SERVICE BULLETIN

N° 139-674

ATA 93 - AIRCRAFT SURVIVABILITY EQUIPMENT (ASE) RETROMOD

This Service Bulletin is issued in order to provide the necessary instruction on how to perform the ASE FWD optical sensor structural provision retromod P/N 3G5310P22711 and the ASE electrical variant P/N 3G9350P03111.

Figure 1

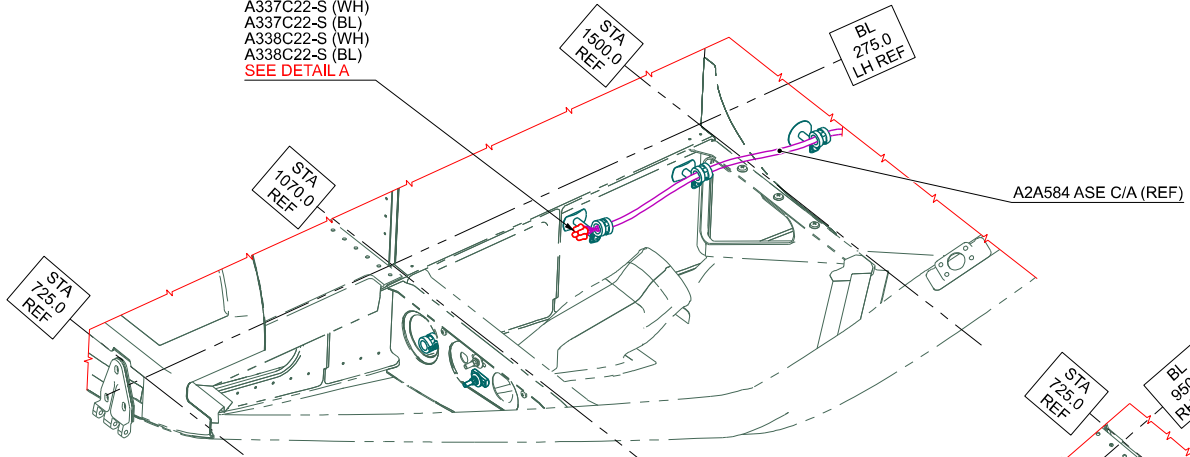
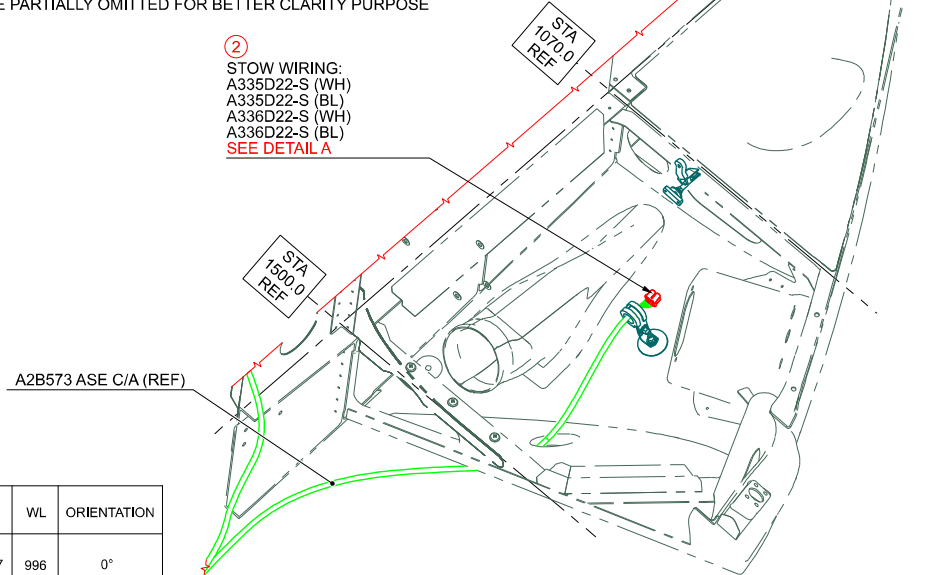
- 2.9 With reference to Figure 1 View looking down lower nose LH side and Figure 5 Wiring Diagram, cut of adequate length the wires marked as A337C22-S (WH), A337C22-S (BL), A338C22-S (WH) and A338C22-S (BL) of the C/A A2A584.

- 2.10 With reference to Figure 1 View looking down lower nose LH side and Detail A,

- install n°4 caps P/N A583A2610W on the end of the wires previously cut.
- 2.11 With reference to Figure 1 Detail A, stow and protect the end of the wires by means of the nomex P/N EN6049-006-08-5 and the tie strap P/N 900004953.

- 2.14 With reference to Figure 1 View looking down lower nose RH side and Figure 5 Wiring Diagram, cut of adequate length the wires marked as A335D22-S (WH), A335D22-S (BL), A336D22-S (WH) and A336D22-S (BL) of the C/A A2B573.

- 2.15 With reference to Figure 1 View looking down lower nose RH side and Detail A, install n°4 caps P/N A583A2610W on the end of the wires previously cut.

- 2.16 With reference to Figure 1 Detail A, stow and protect the end of the wires by means of the nomex P/N EN6049-006-08-5 and the tie strap P/N 900004953.

INSTALL:
A583A2610W CAP (QTY 4)

INSERT THE CONNECTOR ASSEMBLY INTO THE PROTECTIVE PLUG. COVER WITH NOMEX FIBRE SLEEVE AND USE THE CABLE STRAPS TO TIE UP SLEEVE FIRMLY TO THE CONNECTOR CABLING. USE CABLE STRAPS TO FIX THE CONNECTOR ASSY TO THE CABLE LOOM OR SUPPORT.

①
STOW WIRING:
A337C22-S (WH)
A337C22-S (BL)
A338C22-S (WH)
A338C22-S (BL)
SEE DETAIL A

②
STOW WIRING:
A335D22-S (WH)
A335D22-S (BL)
A336D22-S (WH)
A336D22-S (BL)
SEE DETAIL A

Figure 2

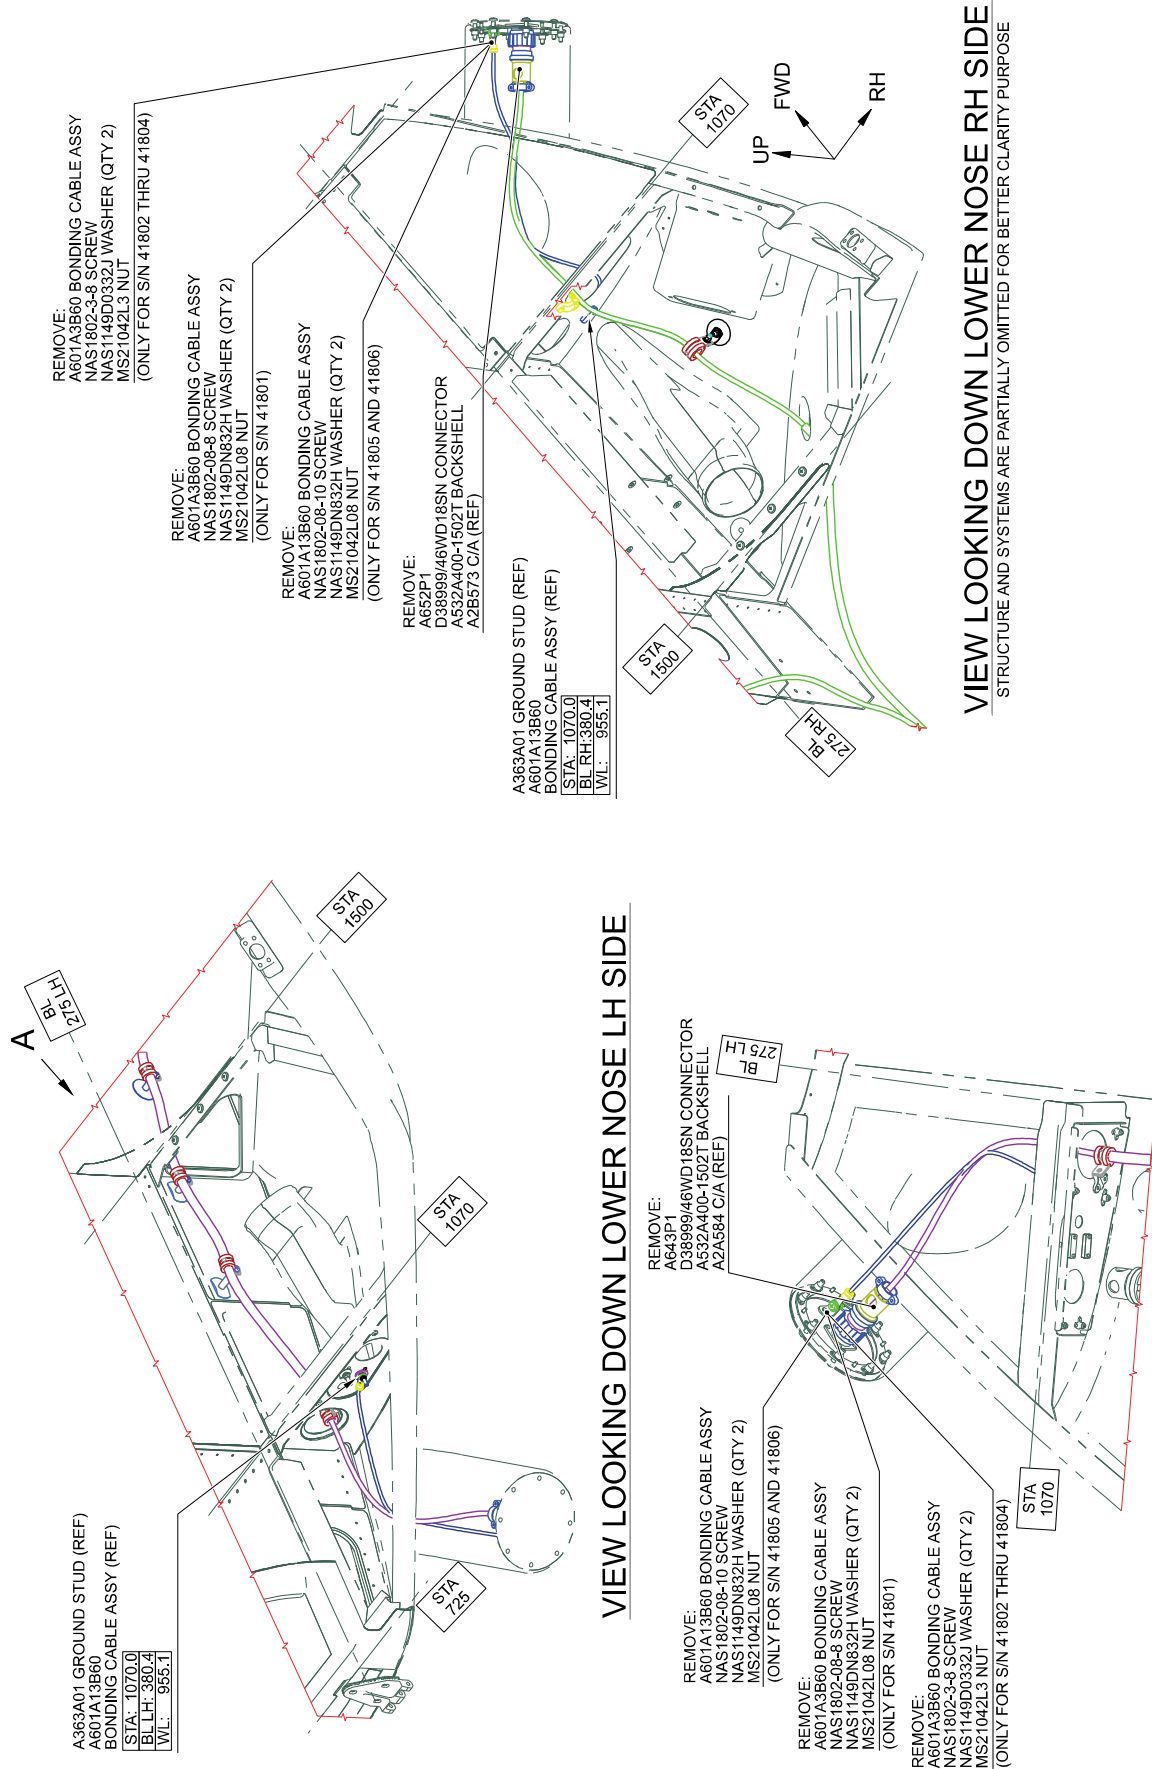
- 2.1 With reference to Figure 2 View looking down lower nose LH side and View A, remove the bonding cable assy P/N A601A3B60, the screw P/N NAS1802-08-8, the nut P/N MS21042L08 and n°2 washers P/N NAS1149DN832H from the LH optical sensor A643 and the ground stud.

- 2.2 With reference to Figure 2 View looking down lower nose RH side, remove the bonding cable assy P/N A601A3B60, the screw P/N NAS1802-08-8, the nut P/N MS21042L08 and n°2 washers P/N NAS1149DN832H from the lower nose RH side from the RH optical sensor A652 and the ground stud.

- 2.5 With reference to Figure 2 View looking down lower nose LH side and View A, remove the bonding cable assy P/N A601A13B60, the screw P/N NAS1802-08-10, the nut P/N MS21042L08 and n°2 washers P/N NAS1149DN832H from the LH optical sensor A643 and the ground stud.

- 2.6 With reference to Figure 2 View looking down lower nose RH side, remove the bonding cable assy P/N A601A13B60, the screw P/N NAS1802-08-10, the nut P/N MS21042L08 and n°2 washers P/N NAS1149DN832H from the lower nose RH side from the RH optical sensor A652 and the ground stud.

- 2.8 With reference to Figure 2 View A, remove the connector A643P1 (connector P/N D38999/46WD18SN and backshell P/N A532A400-1502T) from the C/A A2A584.

- 2.13 With reference to Figure 2 View looking down lower nose RH side, remove the connector A652P1 (connector P/N D38999/46WD18SN and backshell P/N A532A400-1502T) from the C/A A2B573.

Figure 3

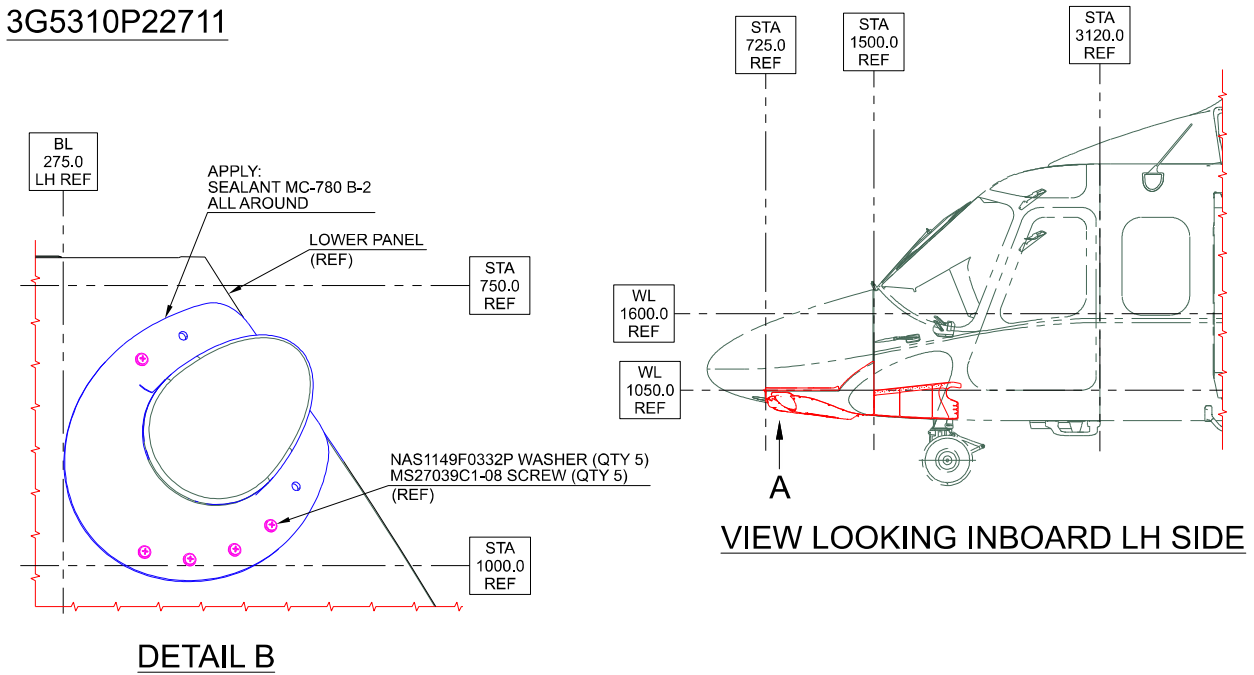
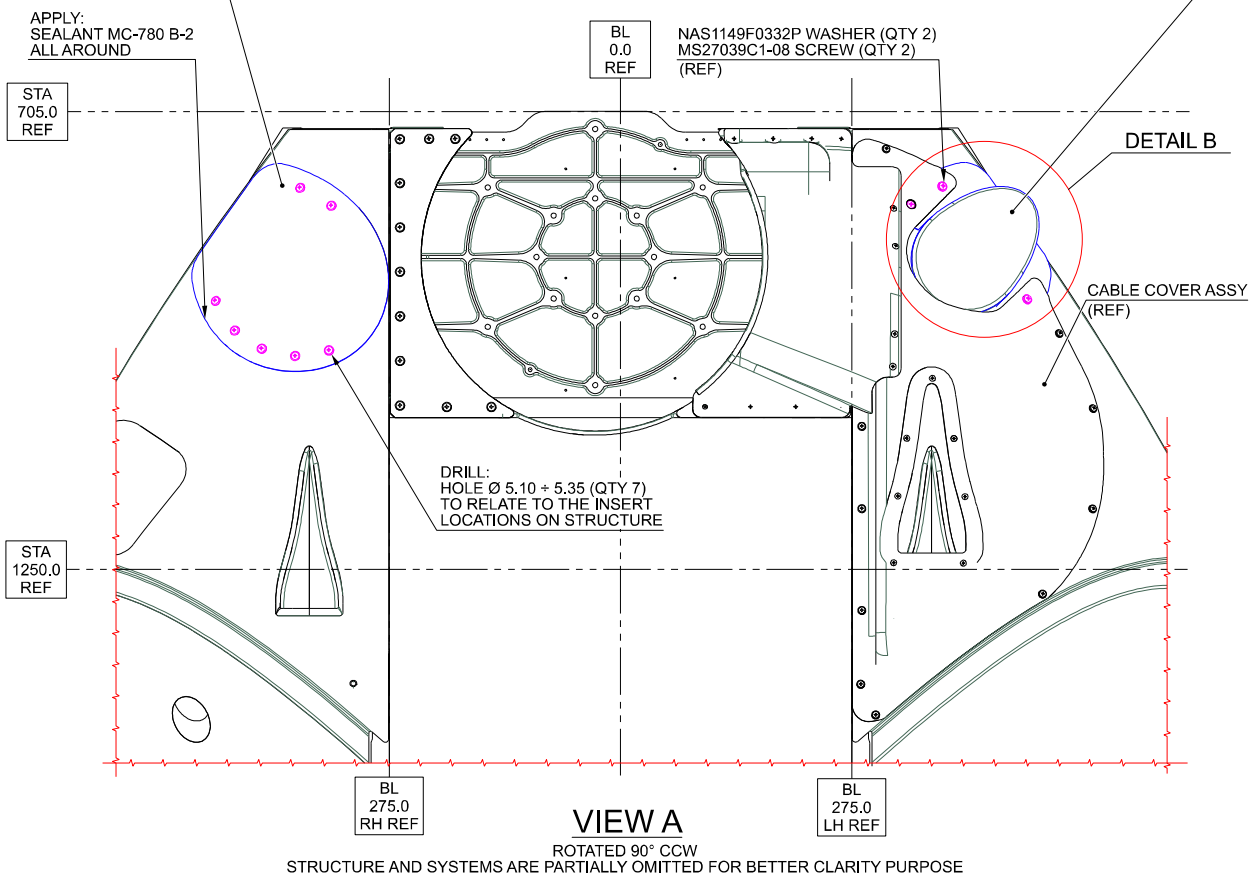
- 3.1 With reference to Figure 3 View A, remove the FWD RH optical sensor support P/N 3G5317A98551, the ring assy P/N 3G5317A99631, the optical sensor cover assy P/N 3G5317A97931, the ring P/N 3G5317A99551 and the existing hardware from the structure. Retain n°7 washers P/N NAS1149F0332P for later reuse.

- 3.2 With reference to Figure 3 View A, temporarily locate the RH cover P/N 3G5318A36051 on the structure and countermark n°7 hole positions in accordance with the existing insert locations.

- 3.3 With reference to Figure 3 View A, drill n°7 holes $\varnothing 5.10 \div 5.35$ thru the RH cover P/N 3G5318A36051.
 - 3.4 With reference to Figure 3 View A, install the RH cover P/N 3G5318A36051 on the structure by means of n°7 screws P/N MS27039C1-06 and n°7 existing washers P/N NAS1149F0332P previously removed.

- 3.5 With reference to Figure 3 View A, apply the sealant MC-780 B-2 (C465) all around

- 3.6 With reference to Figure 3 View A and Detail B, remove the FWD LH optical sensor support P/N 3G5317A98451, the ring assy P/N 3G5317A99631, the optical sensor cover assy P/N 3G5317A97931, the ring P/N 3G5317A99551 and the existing hardware from the structure. Retain the FWD LH optical sensor support P/N 3G5317A98451 and retain n°7 screws P/N MS27039C1-08, n°7 washers P/N NAS1149F0332P and n°7 bushings P/N 3G5317A99451 for later reuse.

- 3.8 With reference to Figure 3 View A and Detail B, install the FWD LH optical sensor support reworked P/N 3G5315P09751 in the same position by means of existing

REMOVE:
3G5317A98551 FWD RH OPTICAL SENSOR SUPPORT
3G5317A99631 RING ASSY
3G5317A97931 OPTICAL SENSOR COVER ASSY
3G5317A99551 RING
EXISTING HARDWARE
REMOVE AND RE-INSTALL:
NAS1149F0332P WASHER (QTY 7)
INSTALL:
3G5318A36051 RH COVER
MS27039C1-06 SCREW (QTY 7)

REMOVE:
3G5317A98451 FWD LH OPTICAL SENSOR SUPPORT (RETAIN)
3G5317A99631 RING ASSY
3G5317A97931 OPTICAL SENSOR COVER ASSY
3G5317A99551 RING
EXISTING HARDWARE
REMOVE AND RE-INSTALL:
NAS1149F0332P WASHER (QTY 7)
MS27039C1-08 SCREW (QTY 7)
3G5317A99451 BUSHING (QTY 7)
INSTALL:
3G5315P09751 FWD LH OPTICAL SENSOR SUPPORT REWORKED
(FOR REWORK SEE FIGURE 68)

Figure 4

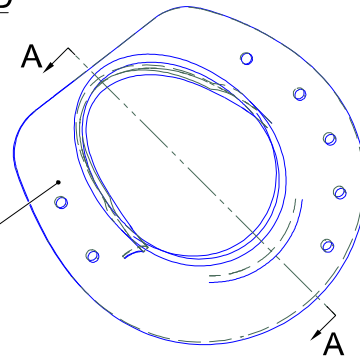
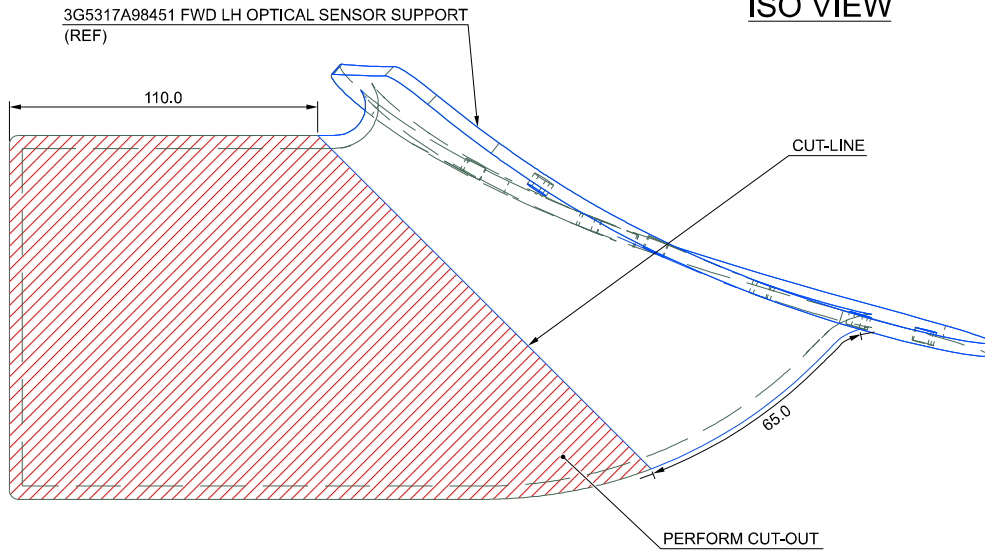
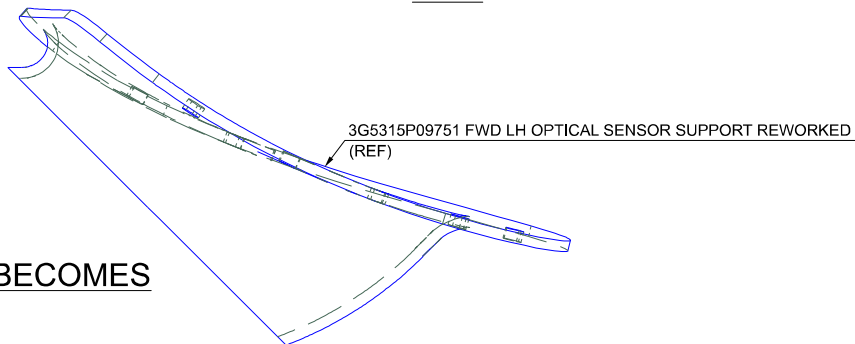
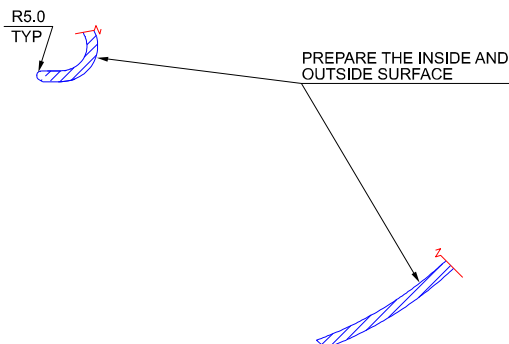
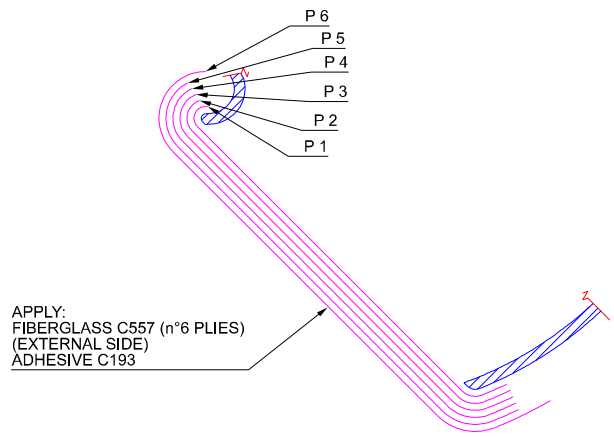
- 3.7 With reference to Figure 4, perform the FWD LH optical sensor support reworked P/N 3G5315P09751 as described in the following procedure:
 - 3.7.1 With reference to Figure 4 Was, Becomes and Schematic Section A-A, perform the indicated cut-out of the FWD LH optical sensor support P/N 3G5317A98451 in accordance with the dimensions shown.

- 3.7.2 With reference to Figure 4 Schematic Section A-A, prepare the inside and outside indicated surface.
 - 3.7.3 With reference to Figure 4 Schematic Section A-A, apply n°6 plies of the fiberglass C557 on the cut-out edges (external side) of the FWD LH optical sensor support P/N 3G5317A98451. Bond with adhesive C193.

- 3.7.5 Vacuum bag the repair area and apply vacuum pressure.
- 3.7.6 Clean and blend by sanding lightly and ensuring no damage to the fibers occurs.
- 3.7.7 With reference to Figure 4 Iso View, remark the FWD LH optical sensor support P/N 3G5317A98451 as the FWD LH optical sensor support reworked P/N 3G5315P09751.

3G5317A98451 FWD LH OPTICAL SENSOR SUPPORT (REF)
REMARK AS:
3G5315P09751 FWD LH OPTICAL SENSOR SUPPORT REWORKED

Figure 5

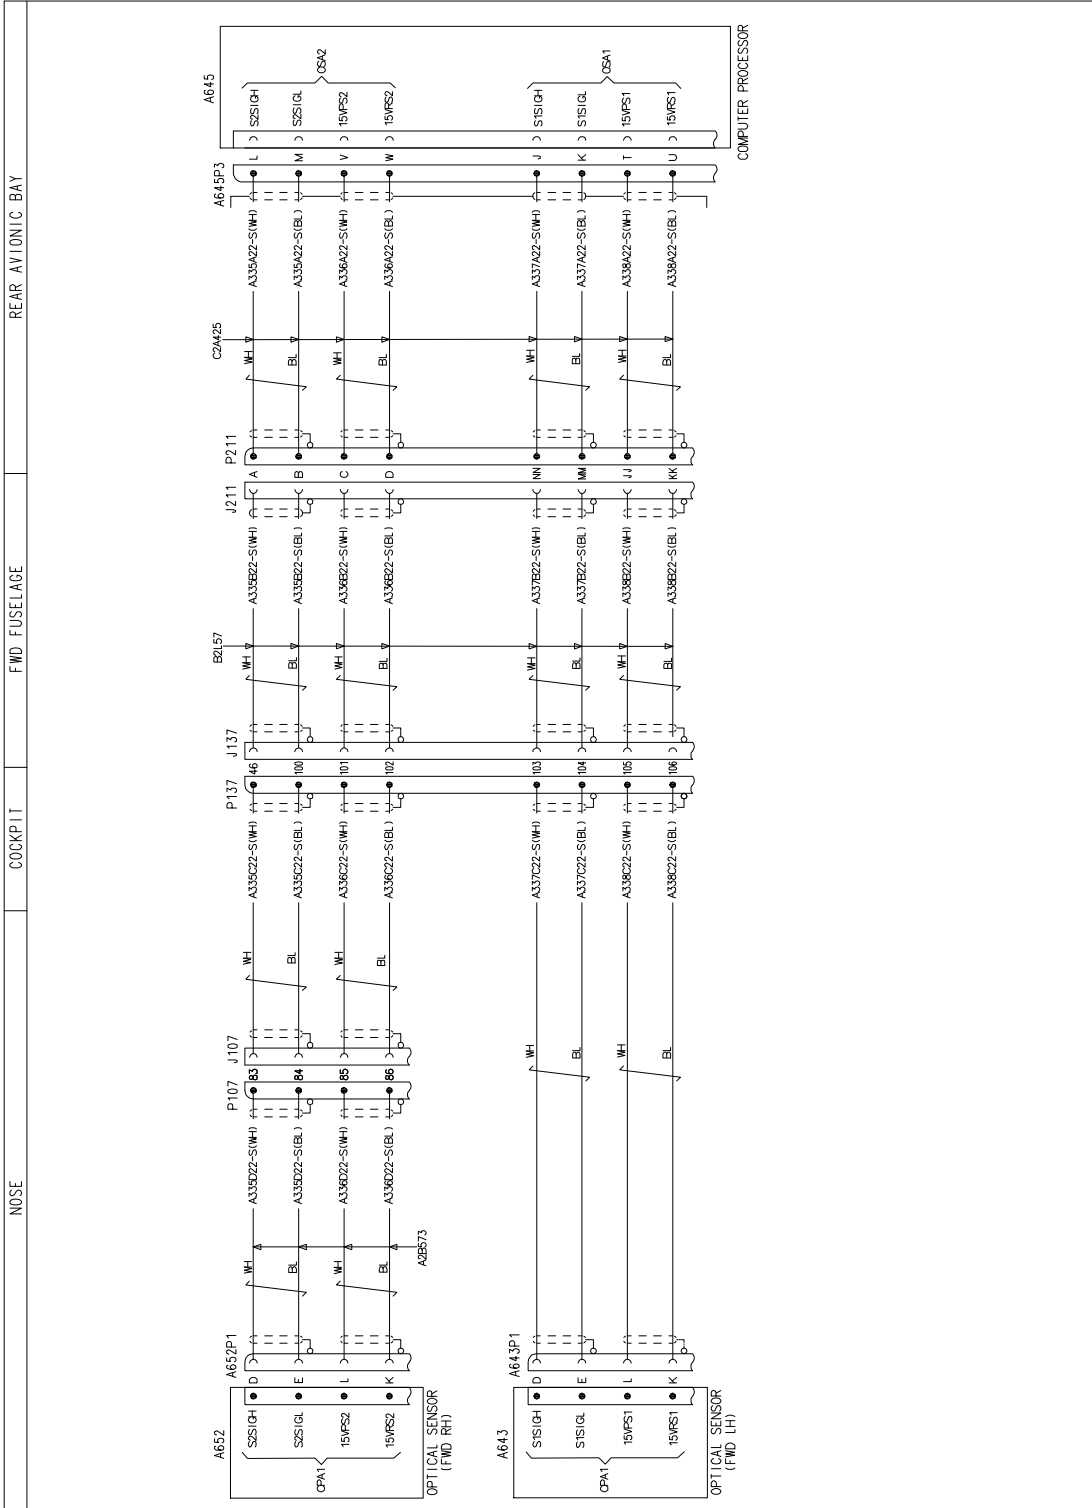
- 2.7 With reference to Figure 1 View looking down lower nose LH side and Figure 2 View A and and Figure 5 Wiring Diagram, disconnect the connector A643P1 of the C/A A2A584 from the FWD LH optical sensor (A643).

- 2.12 With reference to Figure 1 View looking down lower nose RH side and Figure 5 Wiring Diagram, disconnect the connector A652P1 of the C/A A2B573 from the FWD RH optical sensor (A652).
